SERVICE BULLETIN REVISION TRANSMITTAL SHEET

MODEL BD-100-1A10 (CH-350)

Service Bulletin No. 350-76-002

MODIFICATION – ENGINE CONTROLS – UNCONTROLLABLE HIGH THRUST – EASA RETRO-FIT

K1000070356 – Kit – Wiring Modification for UHT
(Sheet 2 of 4, Rev. B)

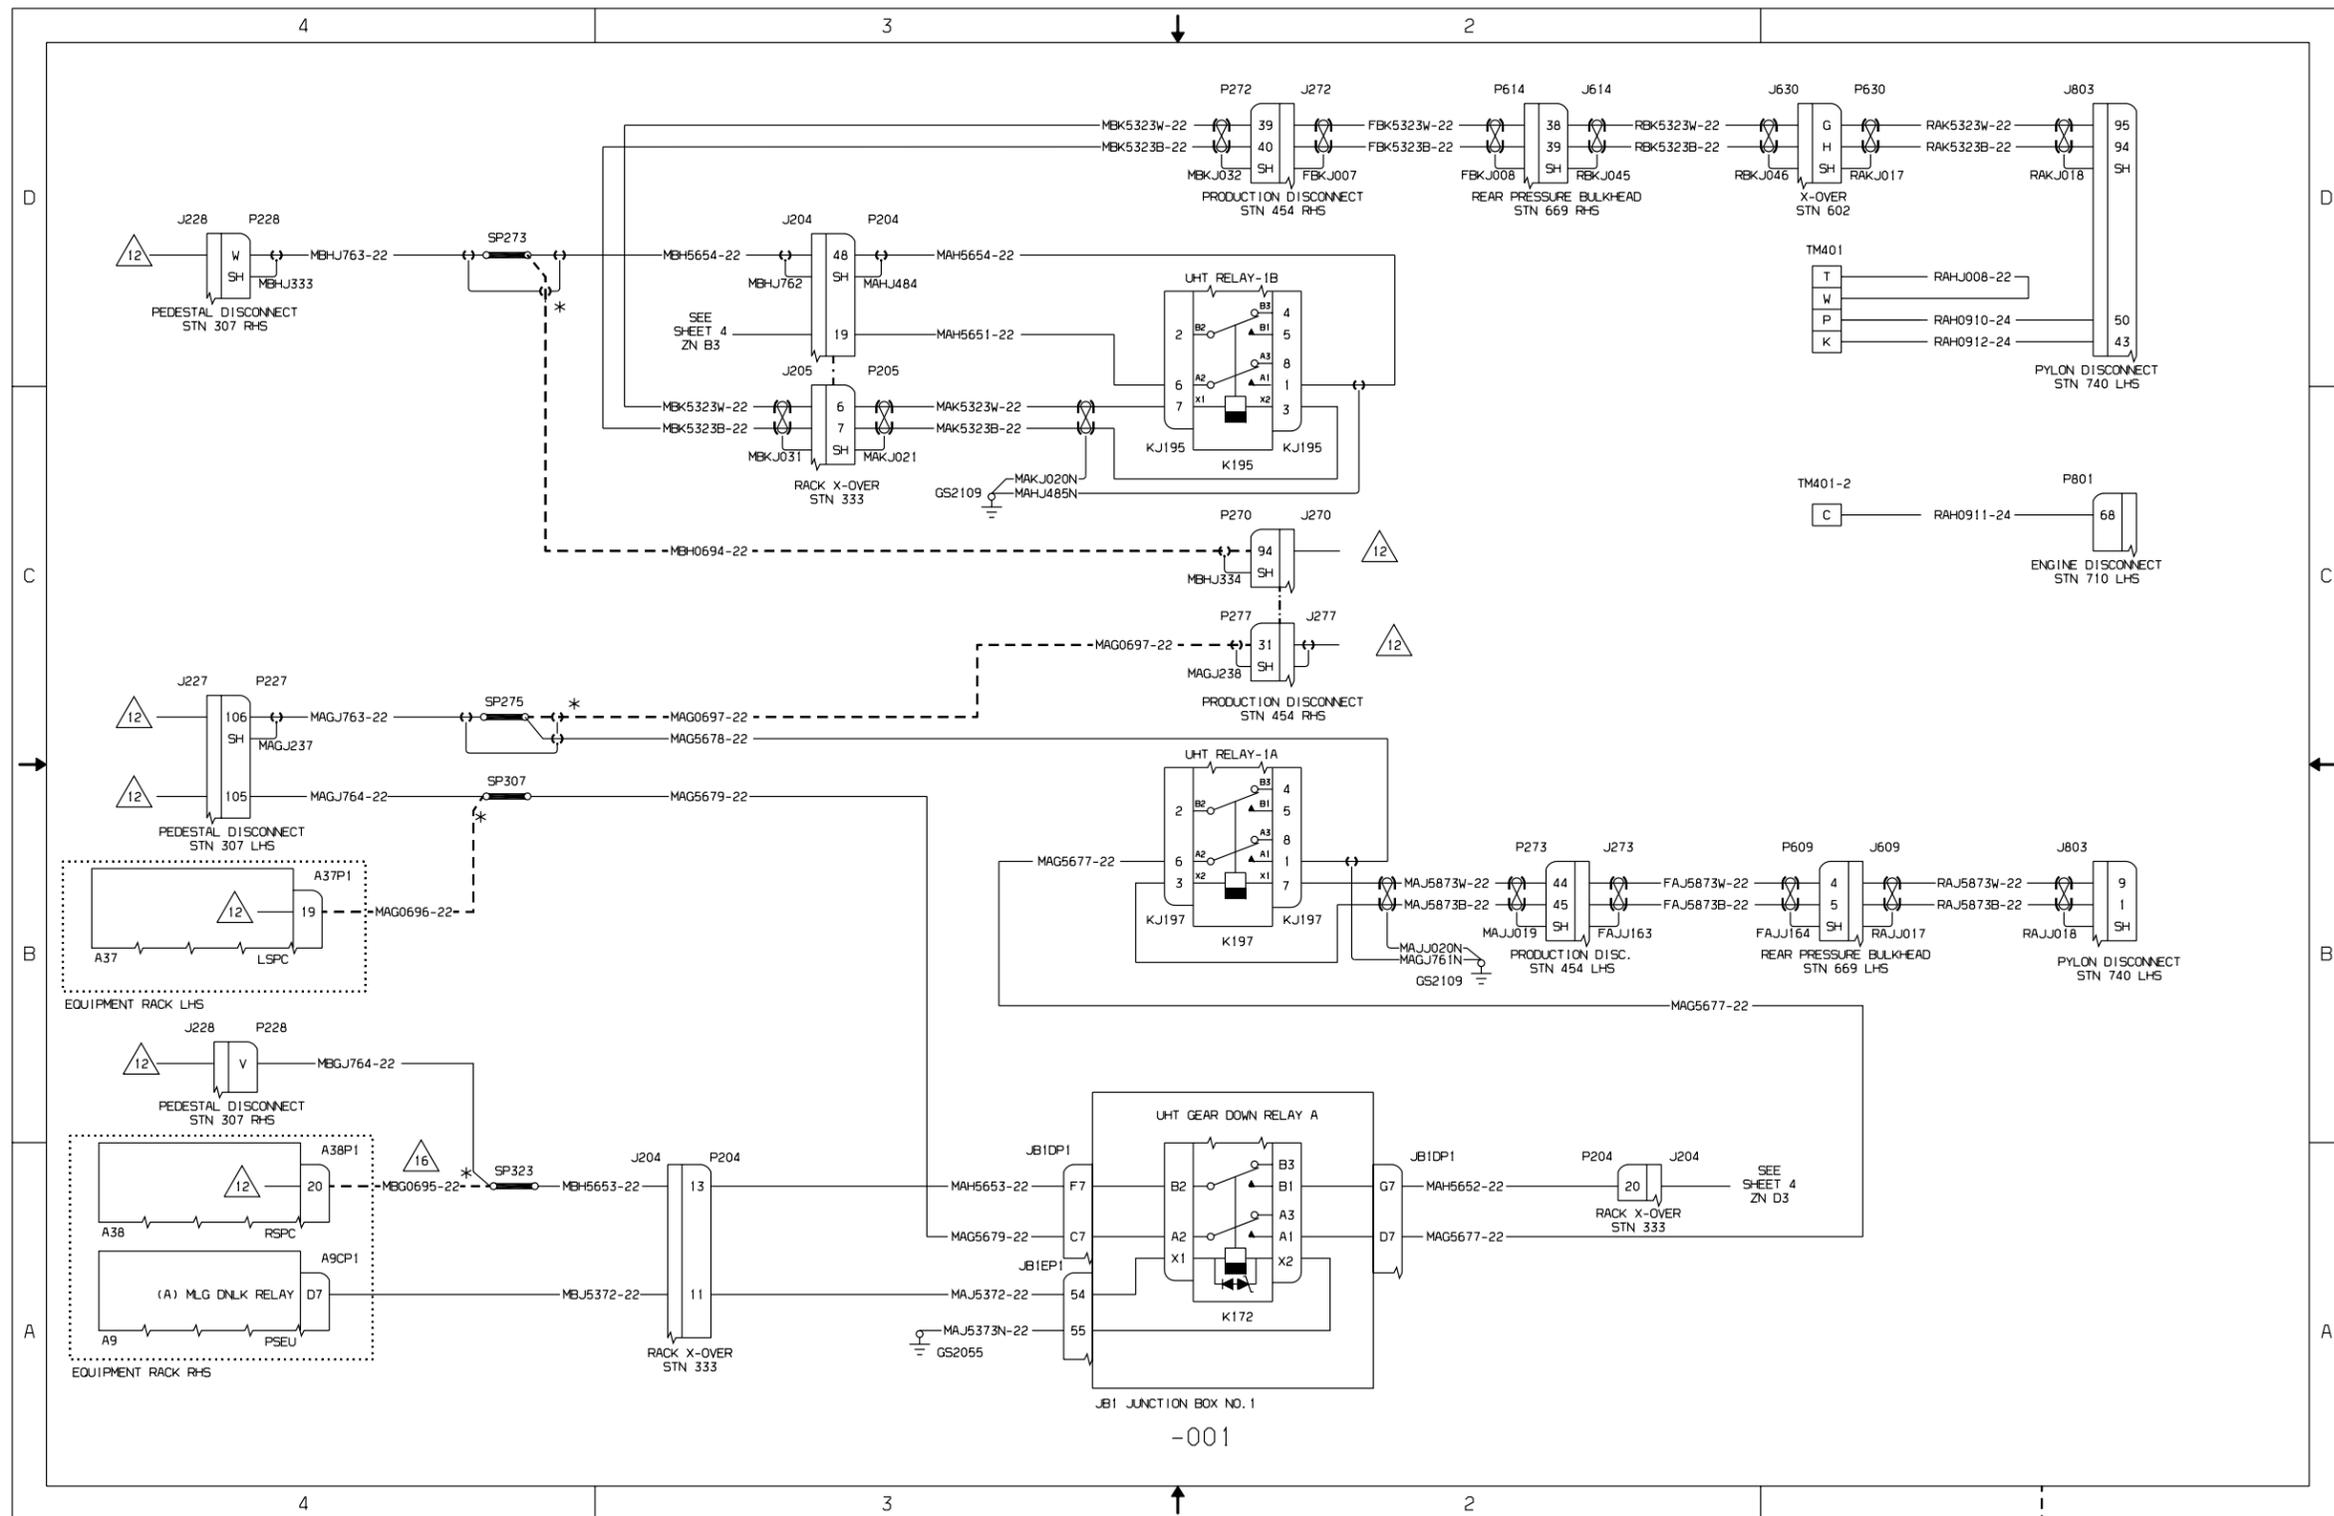
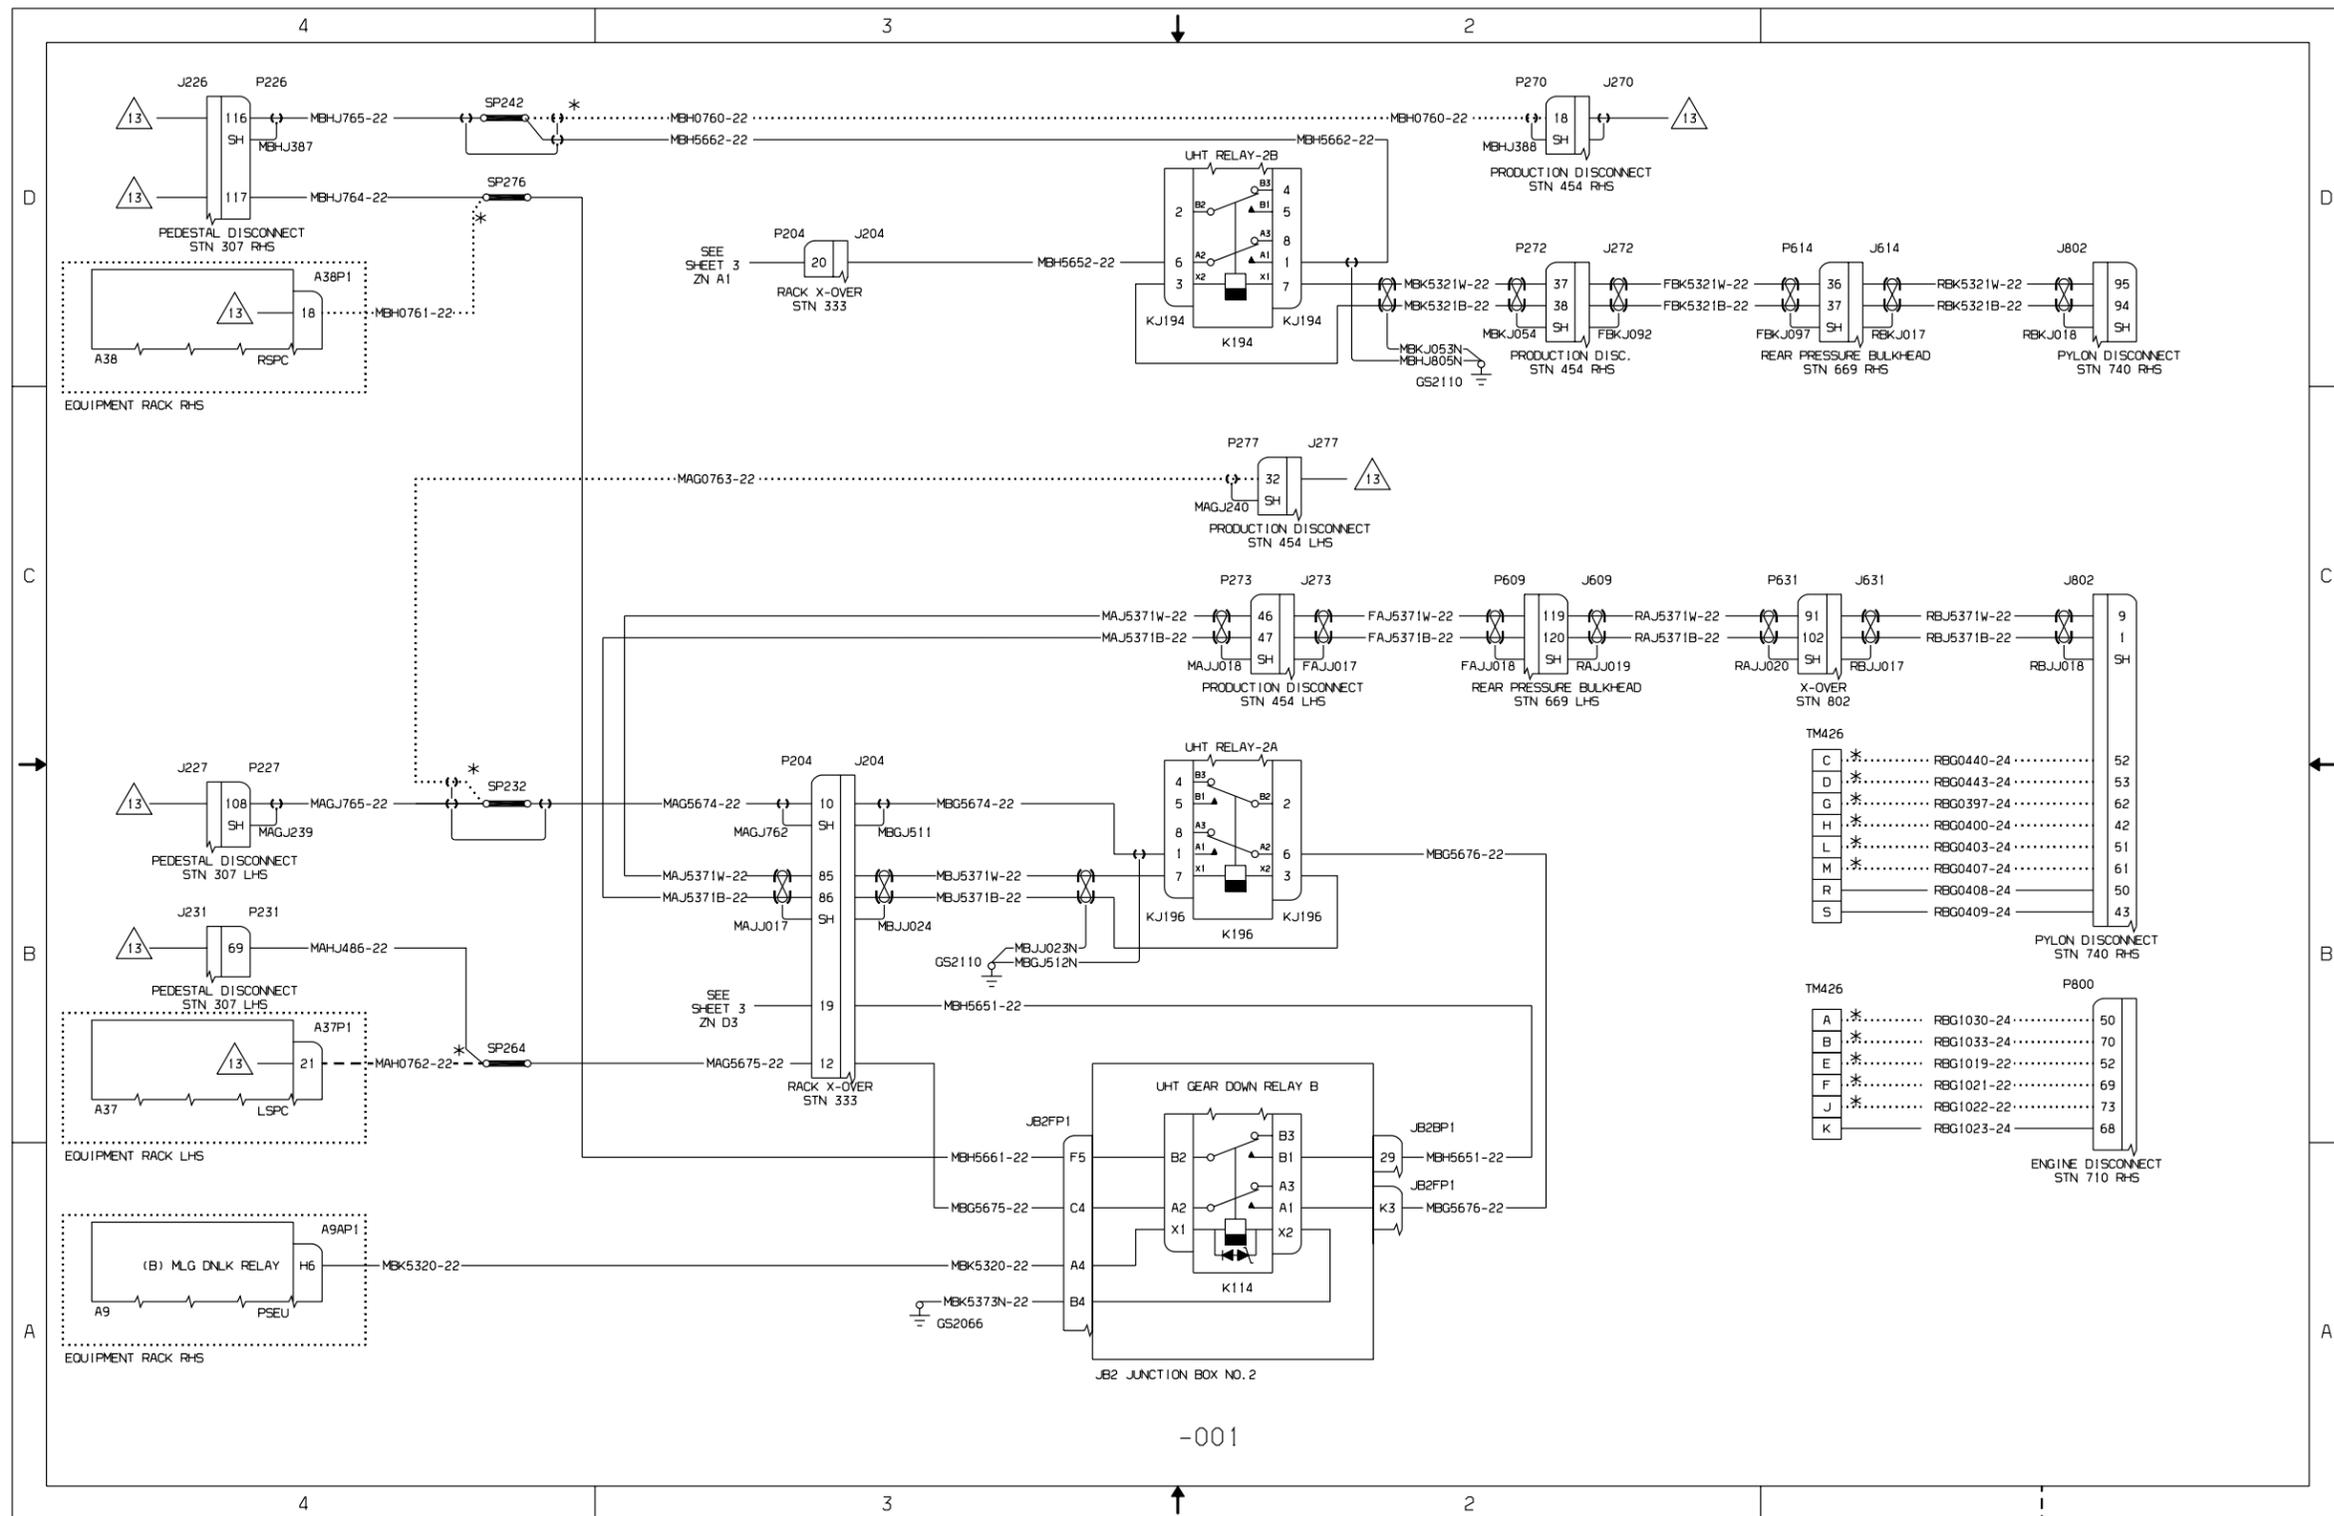
F. PART E — Wiring Modification (refer to Drawing K1000070356)

- (1) Remove the terminal module TM416, Part No. M81714/60-22-05 and replace with terminal module TM426, Part No. M81714/60-22-02.
- (2) Remove the wires that follow:
 - (a) Between engine disconnect, connector P801, pin 97 and terminal module TM401-2, pin C, remove wire RAH0907-22.
 - (b) Between pylon disconnect, connector P800, pin 97 and terminal module TM416, pin Y, remove wire RBG1020-22.
 - (c) Between terminal module TM416, pin E and pin J, remove wire RBGJ150-22.
 - (d) Between terminal module TM416, pin S and pin Z, remove wire RBGJ160-22.

NOTE: Wire MBHJ763 has a maximum length of 12 inches. Refer to drawing K1000070356.
 - (d) Connect the wire MBHJ333 to the shield on connector P228. Refer to SPM-WM 20-15-00.
